**ORDINANCE NO. 5088**

**AN ORDINANCE APPROVING A TENTATIVE SUBDIVISION FOR A 280 LOT, PHASED SINGLE-FAMILY DETACHED RESIDENTIAL DEVELOPMENT AT THE NORTHEAST QUADRANT OF THE INTERSECTION OF NW HILL ROAD AND NW BAKER CREEK ROAD**

The Planning Department received an application (S 1-19) from Stafford Development Company, LLC requesting approval of a Tentative Subdivision (more than 10 lots) for a 280 lot, ten phase single-family detached residential development; and

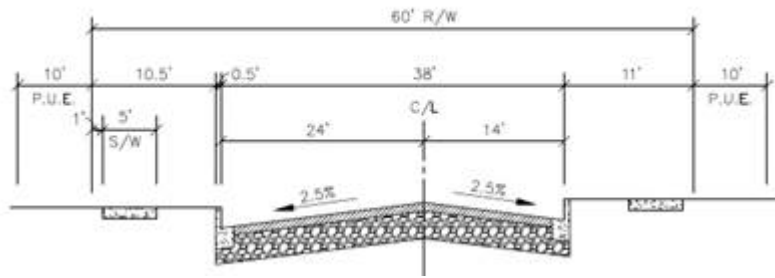
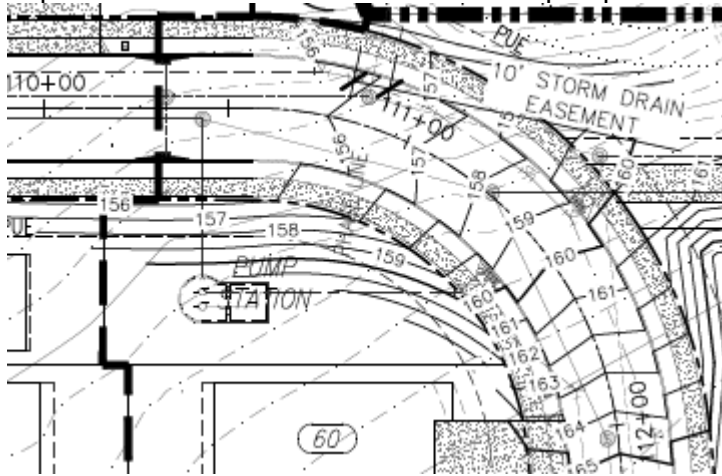
- The proposed intersection of Gregory & Augustine Streets shall be redesigned such that the intersection angle is as near to 90° as practical. The current “Y” configuration is not consistent with MMC Section 17.53.101(F):

- MMC 17.53.101(O) indicates that the public alley in the City's street standards applies to commercial and industrial districts, not to residential developments. Thus, the proposed alleys on the proposal shall be private, and shall be maintained by the adjacent property owners or the Home Owners Association.
- Meadows Dr and Shadden Dr are proposed to have an offset crown to accommodate a right turn lane (see cross-section below). We would prefer see the City's typical "Teepee" section so that the curb elevations match on each side of the street.

- The proposed sanitary sewer pump station site appears to be steeply graded. The pump station site will need to be designed with a site driveway that accommodates the Wastewater Services department's service vehicles so that the pump station can be adequately maintained:

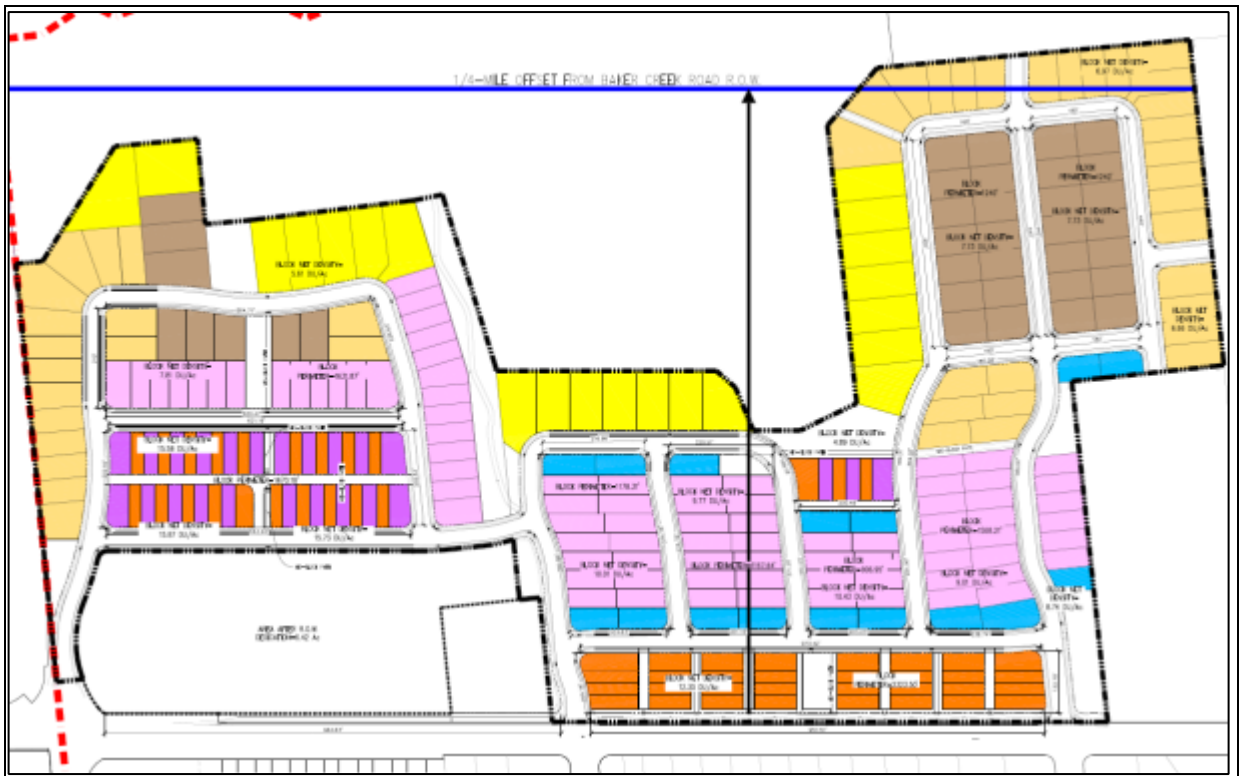
**FINDING: SATISFIED.** The City concurs with the applicant's findings, and adds that the Planned Development includes a phasing pattern that results in greater residential densities closer to Baker Creek Road (which is designated as a minor arterial street), the neighborhood commercial uses that will be included in the commercial area near the intersection of NW Hill Road and NW Baker Creek Road, and the planned public transit route along NW Baker Creek Road. The greater residential densities, which transition in density from higher density in the southern portion of the site to lower density in the northern portion of the site, is identified in EXH-4 and shown below:
